Hume Coal and Berrima Rail Project

Response to the Independent Planning Commission Assessment Report dated 27 May 2019

Prepared for Hume Coal Pty Ltd
April 2020

Figure 9.6 Distribution of wind speed and direction – Hume 2 meteorological station – 2013 to 2018

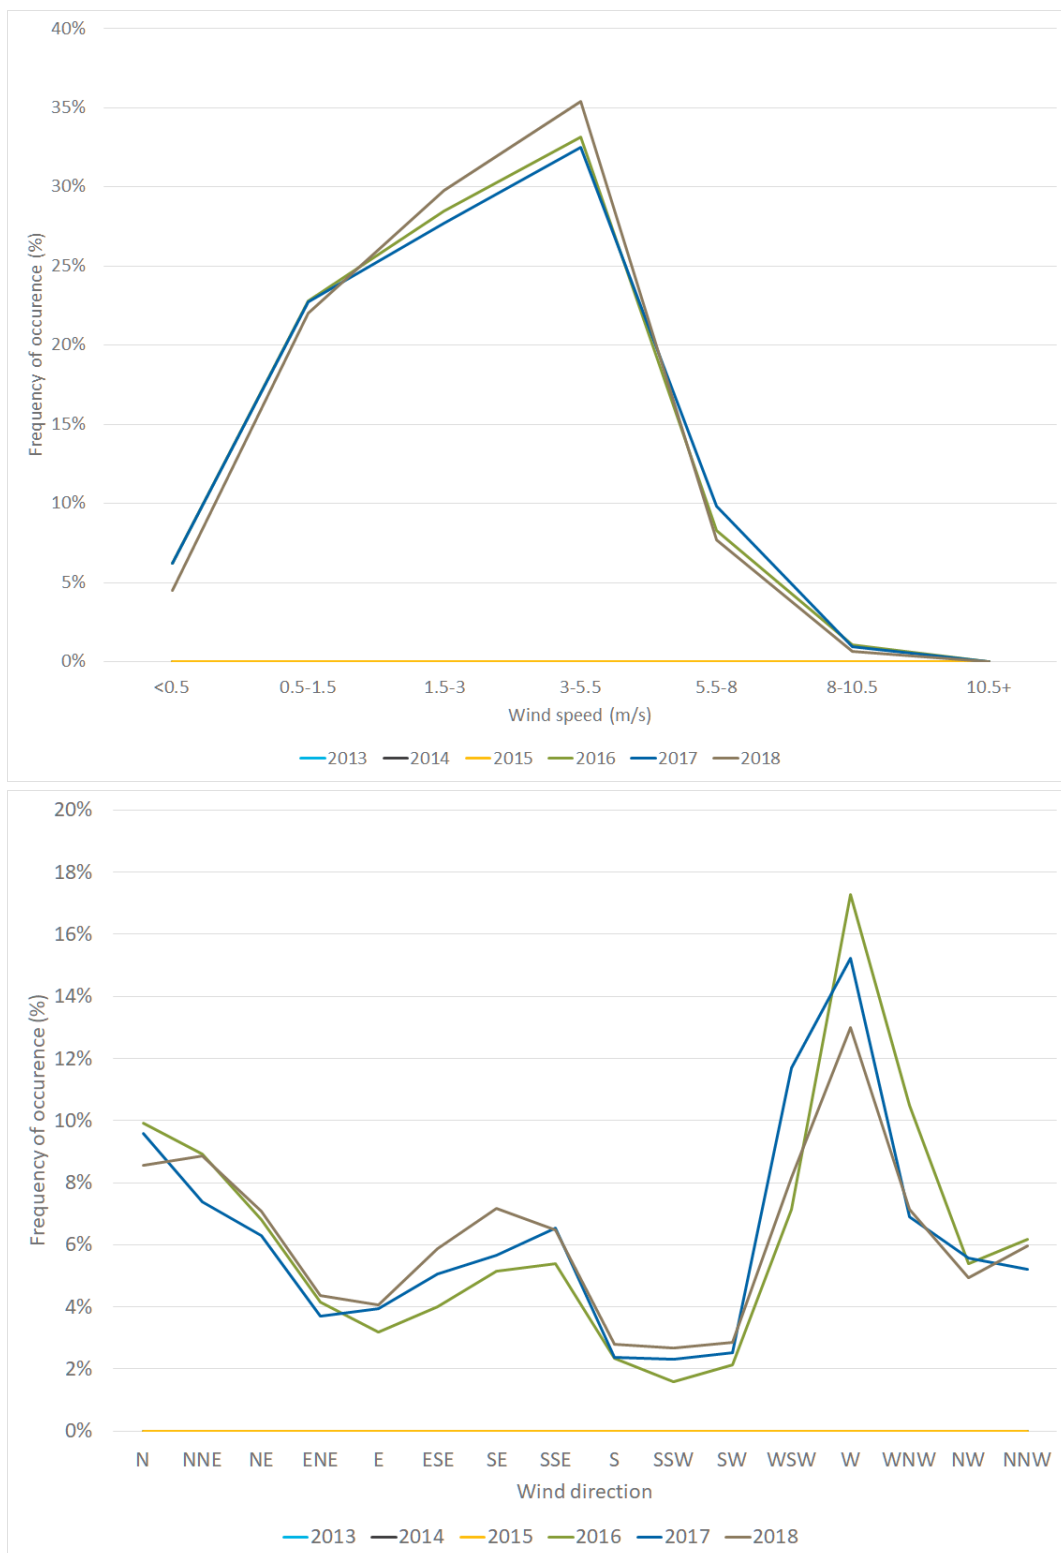
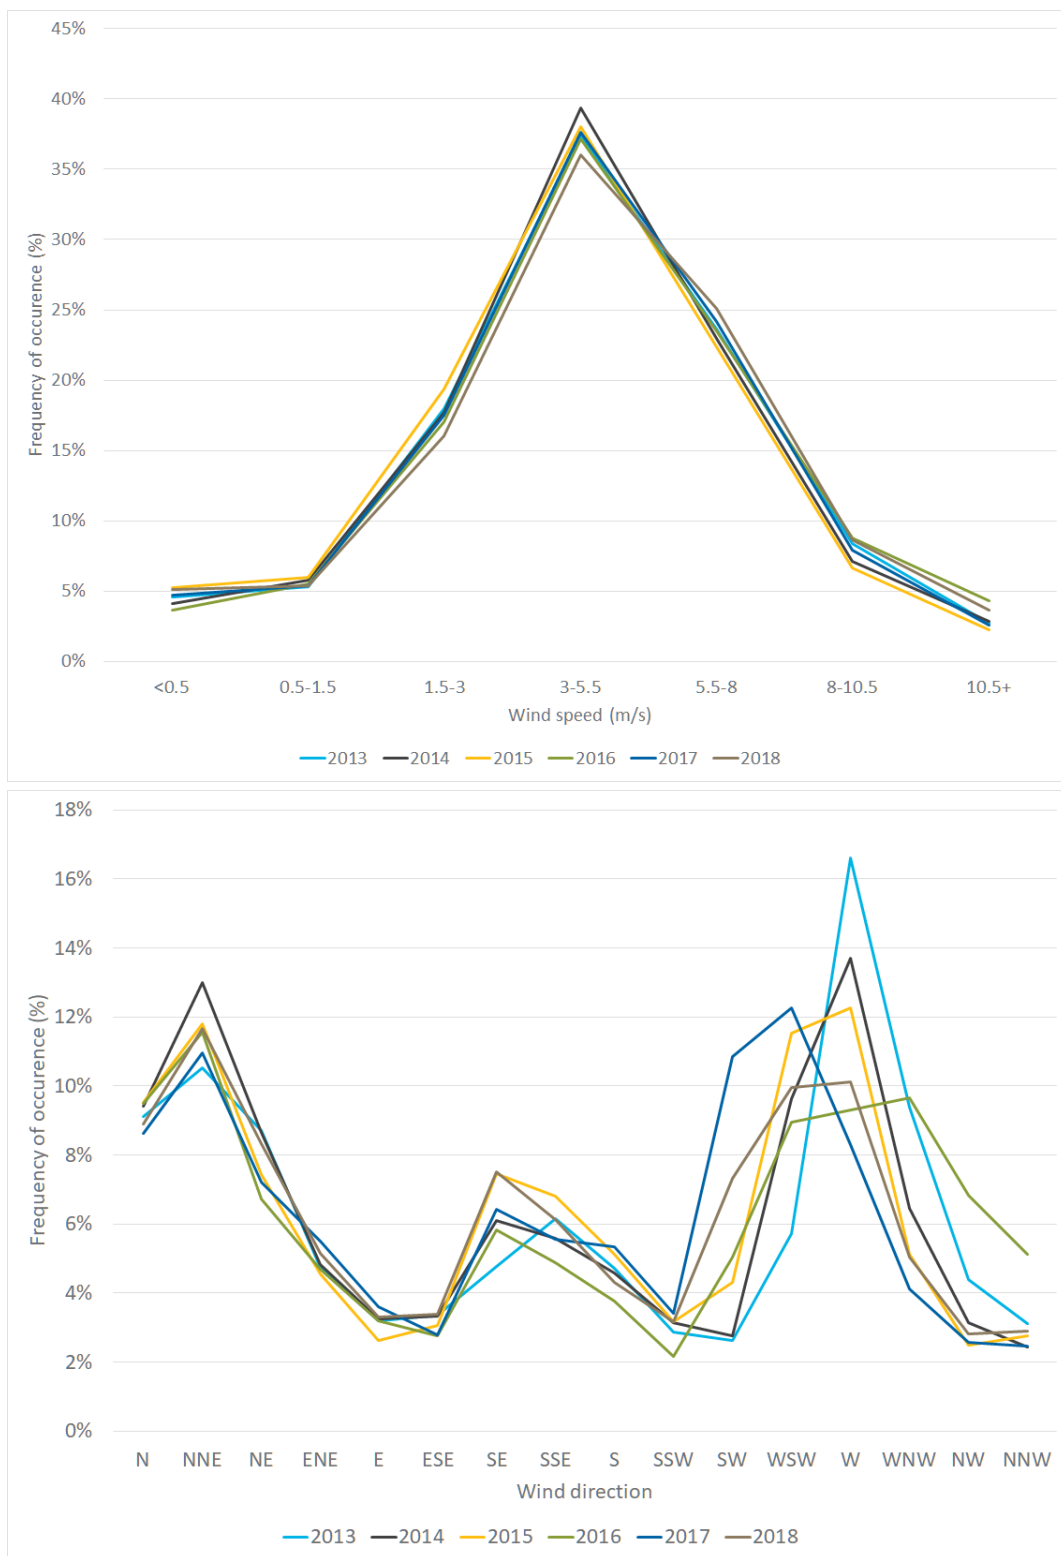
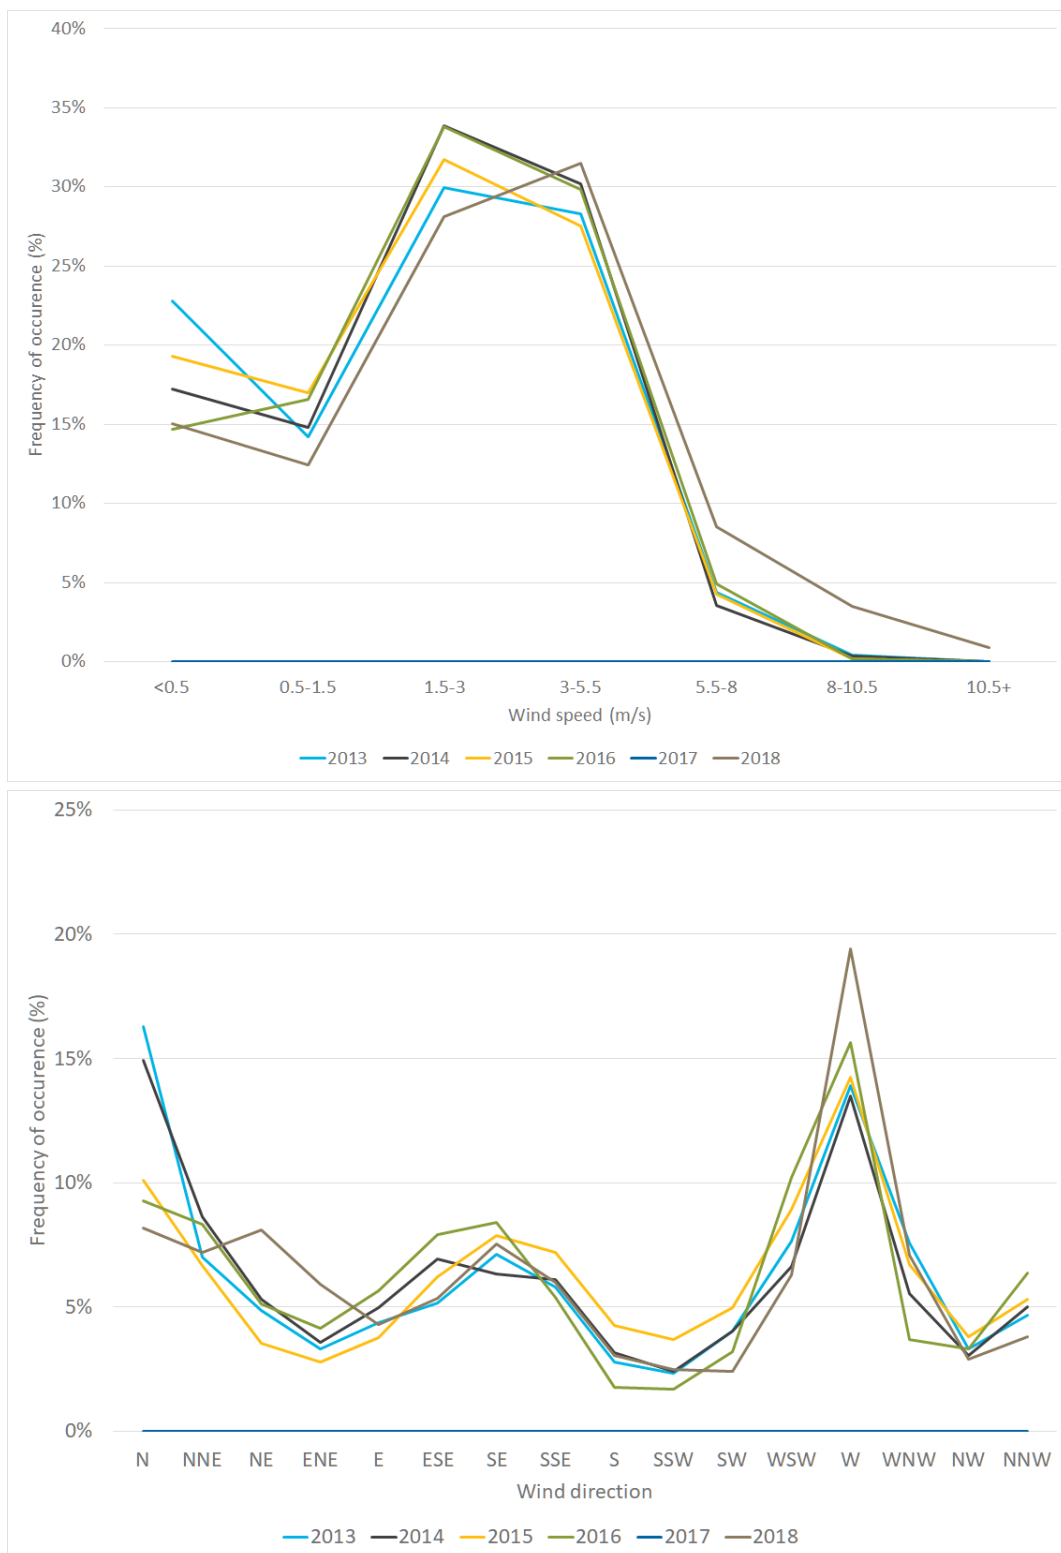
Reference number	IPC recommendations	Summary response
R12	The Department's Final Assessment Report should confirm the suitability of the assumptions in the Applicant's modelling in relation to the prevailing wind data utilised as this was questioned by members of the public in submissions.	<p>Analysis of annual wind roses for the four monitoring stations showed the consistency and similarity in recorded wind speed and direction profiles over a four-year basis. The analysed data supported the use of the 2013 meteorological monitoring datasets used for the AQIA undertaken for the EIS. The use of the different meteorological datasets addresses any potential uncertainty relating to the suitability of wind speed or directions applied in the dispersion modelling.</p> <p>It is repeated that the wind speeds recorded at the BoM Moss Vale dataset in the modelling are the highest of the four reviewed monitoring resources. The use of elevated wind speeds (average and gust conditions) from BoM Moss Vale AWS in the emission calculations returns the highest potential for dust emission generation. Consequently, the use of the BoM Moss Vale AWS provides an upper bound estimate of emissions from the Project.</p> <p>As demonstrated in the AQIA and within this chapter, the dispersion modelling is based on two meteorological datasets that are representative of the range of dispersion conditions likely to be experienced in the local area. Therefore, it is considered that the likely impacts from the Project at surrounding residences and community centres have been robustly quantified.</p> <p>It is noted that in the submission from the EPA to DPIE, dated 30 June 2017, the EPA review comments relating to the AQIA "did not identify any issues that have the potential to alter the overall conclusions and outcomes of this assessment".</p>

To further demonstrate the suitability of the monitoring data adopted in the AQIA, data recorded at all four stations has been collated and analysed between 2013 and 2018. Interannual wind roses are presented for Hume 1 (Figure 9.1), Hume 2 (Figure 9.2), BoM Moss Vale (Figure 9.3) and Boral Berrima (Figure 9.4). Further, frequency distribution plots for wind direction and wind speed are presented for each station between Figure 9.5 and Figure 9.8.

The following points are made in relation to the annual wind roses and frequency distribution plots presented between Figure 9.1 and Figure 9.8:

- across all stations, the wind roses presented illustrate similarity in the recorded wind speed and direction profiles on an inter-annual basis;
- all stations and years exhibit similar dominant wind direction profiles to the data analysed for the AQIA, namely a dominance of westerly, south-easterly and north-easterly air flow;
- the average wind speed and frequency of calm winds presented for each site and year are consistent with the 2013 dataset that was adopted for the dispersion modelling in the AQIA;
- the recorded wind speeds at the BoM Moss Vale AWS are consistently higher than the other presented monitoring stations, consistent with the analysis from the AQIA; and

- the Hume 2 wind roses recorded from 2016 onwards illustrate a similar profile to the wind roses presented for Hume 1 between 2013 and 2018, supporting the use of the Hume 1 station data in the AQIA dispersion modelling.

Despite issues with completeness of monitoring data from the accessed monitoring resources, it is considered that the data analysed above supports the use of the 2013 meteorological monitoring datasets from the BoM Moss Vale AWS and Hume 1 monitoring stations in the AQIA. It is reiterated that the dispersion modelling conducted utilised two complete 12-month meteorological datasets, which is beyond the recommendations of the Approved Methods for Modelling, therefore confirms the suitability of the assumptions used. The similarity in wind direction profiles observed across multiple monitoring data resources and years, is considered consistent and therefore the use of the two meteorological datasets addresses any potential uncertainty relating to the suitability of wind speed or directions applied in the dispersion modelling is justified.
